Inspection of Automatic Sprinkler System

Yekani - East London Industrial
Development Zone
Pump house and tanks only

UNC.8029

Photo 2

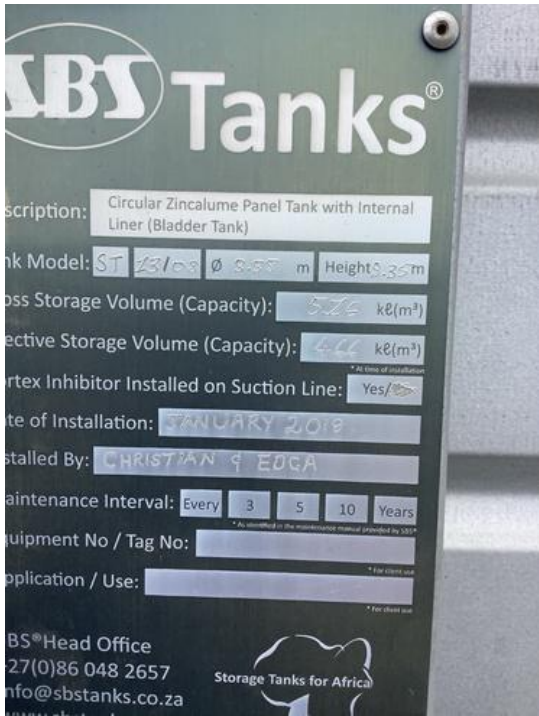
The holes cut into the top of the tank must be repaired

Item 2	
► Description	Suction line inclines towards the pump. Suction lines must be laid truly horizontal or must fall towards the pump for pumps under positive head conditions. In order to prevent any air becoming trapped within this pipework, we recommend that an automatic air release valve be installed.

Photo 20

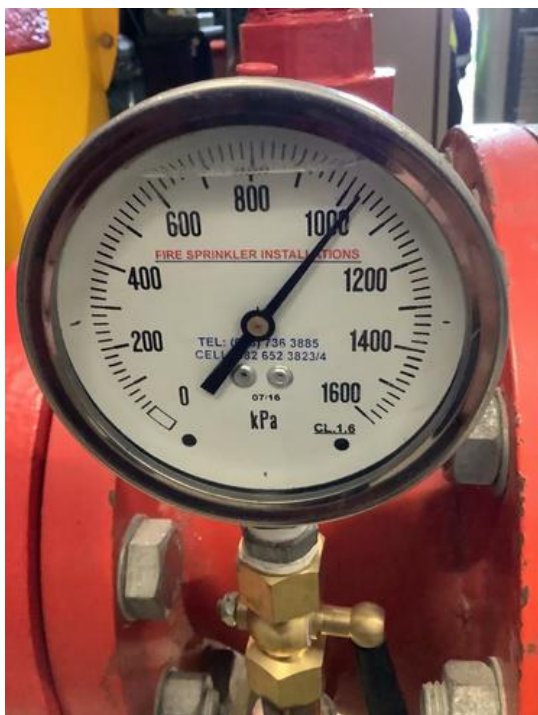
6.6.4 Battery 1 - Button Depressed	Engine Started
6.6.5 Battery 2 - Button Depressed	Engine Started
6.6.6 Battery 1 & 2 - Button Depressed	Engine Started
6.6.7 RPM Recorded 1800	
6.6.8 Churn Pressure (kPa) 1440 	
Photo 19	
6.6.9 Flow Test Recorded 9717 l/min @ 1050 - 60 = 990 kPa The correct flow and pressure requirements must be verified and engraved/stamped on the plate provided
